Date: August 15, 2022
To: Honorable Mayor and City Council Members
From: Michael Diaz, Director of Community Development
Subject: **CITIES OF CLAREMONT AND UPLAND CORRESPONDENCE RELATED TO MONTCLAIR STATION PROJECT/HUNTINGTON DRIVE**

Subject: **Review Services for Alexan Montclair Station: Claremont Boulevard/1st Street – Huntington Drive Operations Assessment (revised) Technical Memorandum, Dated: July 7, 2021**

To: Tony Ditteaux, TCR
From: Amanda Meroux, EIT, Assistant Transportation Engineer
Dennis Pascua, Transportation Services Manager
Subject: Alexan Montclair Station: Claremont Boulevard/1st Street – Huntington Drive Operations Assessment (revised)
Date: July 7, 2021
cc: Todd Phillips, TCR
Erin Gustafson, TCR
Attachment(s): Figure 1 – Proposed Site Plan (Scheme B)
Figure 2 – Project Trip Distribution and Assignment
Figure 3 – Existing Peak Hour Traffic Volumes Re-Assignment w/ Huntington Drive Extension
Figure 4 – Buildout Year Peak Hour Traffic Volumes Re-Assignment w/ Huntington Dr. Ext.
Figure 5 – Existing plus Project Traffic Volumes
Figure 6 – Buildout Year (2040) plus Project Traffic Volumes
Attachment A – Raw Traffic Counts
Attachment B – LOS and SimTraffic Workshee

Figure 2
Project Trip Distribution and Assignment

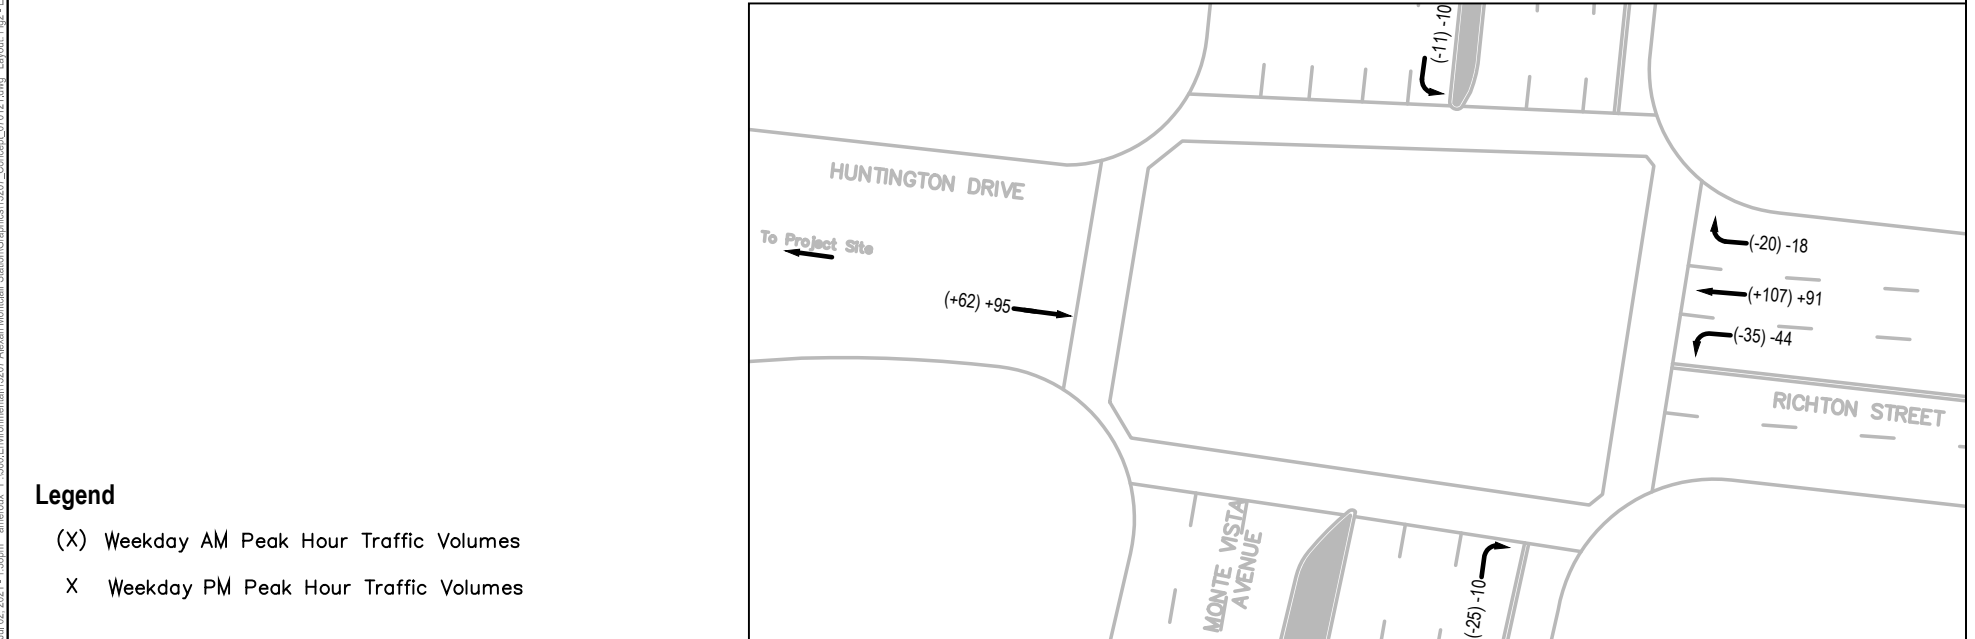
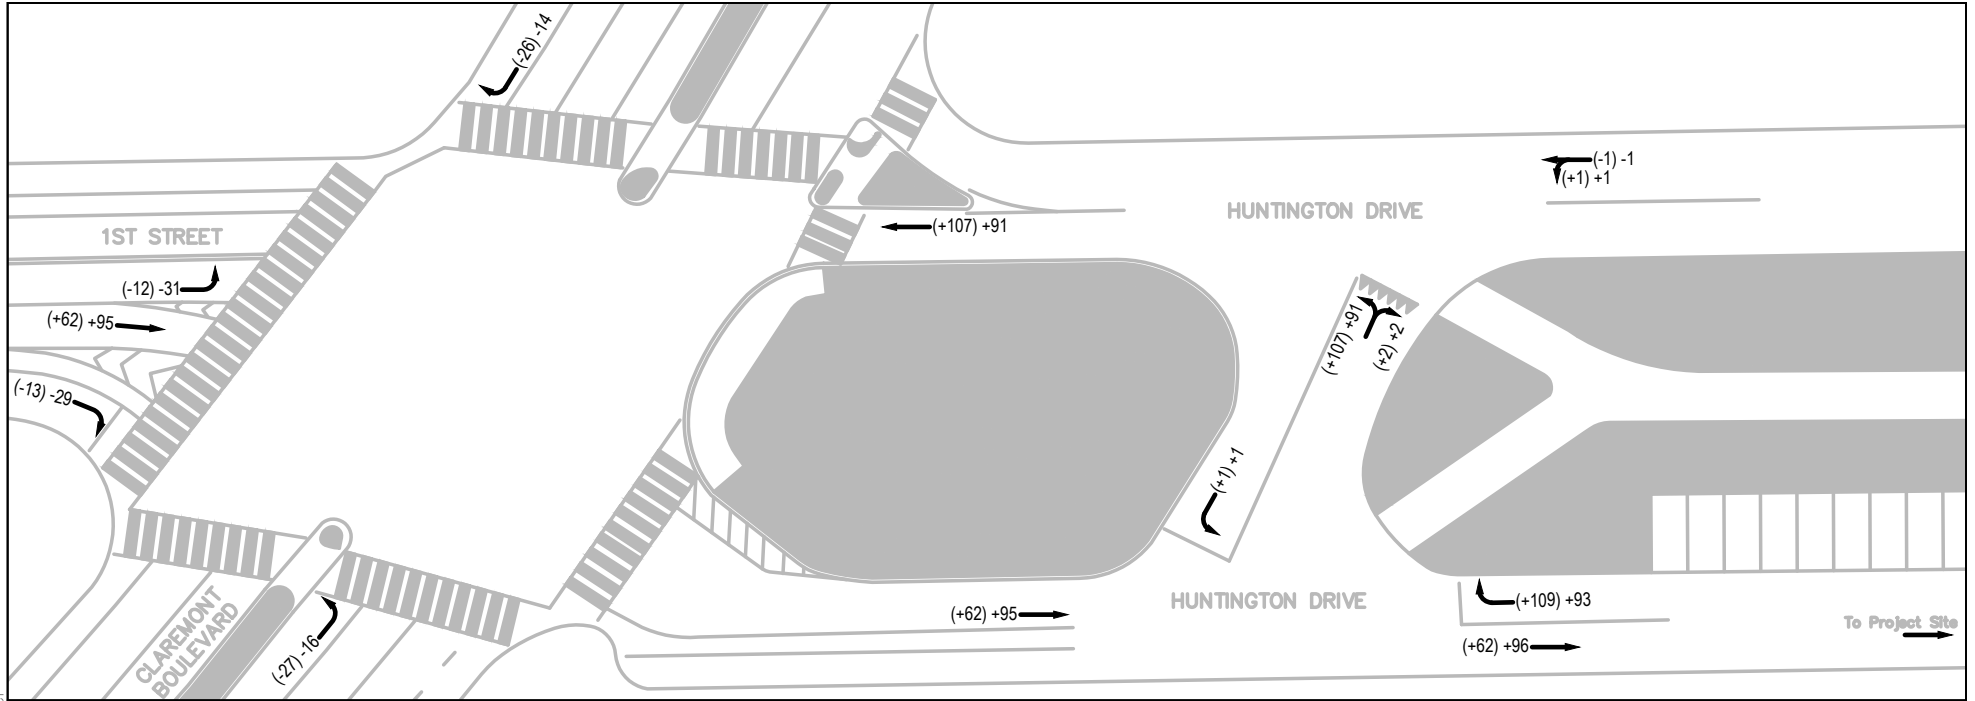
- The trip distribution assumptions are not clearly shown. Provide the percentages on the figures as well
- Due to the new roadway, the memorandum shall address how traffic will be redistributed in area of influence, not just within the immediate vicinity of the development
